Subject: **Submittal of DCM Consistency Certification** for the proposed Wilmington Bypass, from US 17 north of the NC 87 intersection in Brunswick County to US 421 in New Hanover County. TIPS R-2633AA&AB and R-2633B. WSB. 34491.1.3.GV2, 34491.3.ST1, and 34491.1.2.

Subject: Minutes from Interagency 4B Hydraulic Design Review Meeting
On August 22, 2007 for R-2633A in Brunswick County

Subject: Minutes from the **Interagency 4C Concurrence Meeting** for Hydraulic Design & Permit Drawings Review on August 18, 2010 for **R-2633AA&AB in Brunswick County**

**R-2633AA&AB
 WETLAND SITE MAP**
 SUBMITTED: 09-14-10

Sheet 40

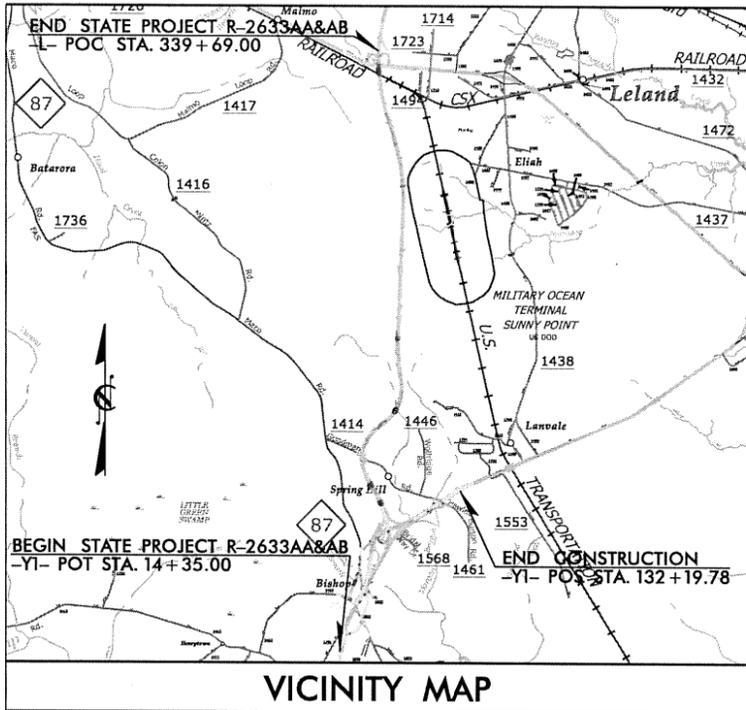
- The bridge over Cartwheel Branch will serve as a small wildlife crossing, as well as to span wetlands. The crossing was set with a 10' horizontal offsets from the wetlands, and has a minimum 4.0' vertical clearance.
- The wetland mitigation site under the bridge will be removed from the project due to the cost of relocating the waterline.
- Hand Clearing needs to be added to the PDE at the ditch entering the wetlands
- The hand clearing needs to be removed from inside the stream boundary.
- The Location Survey stream flow arrow needs to be adjusted and NEU plans to verify the wetland boundaries.
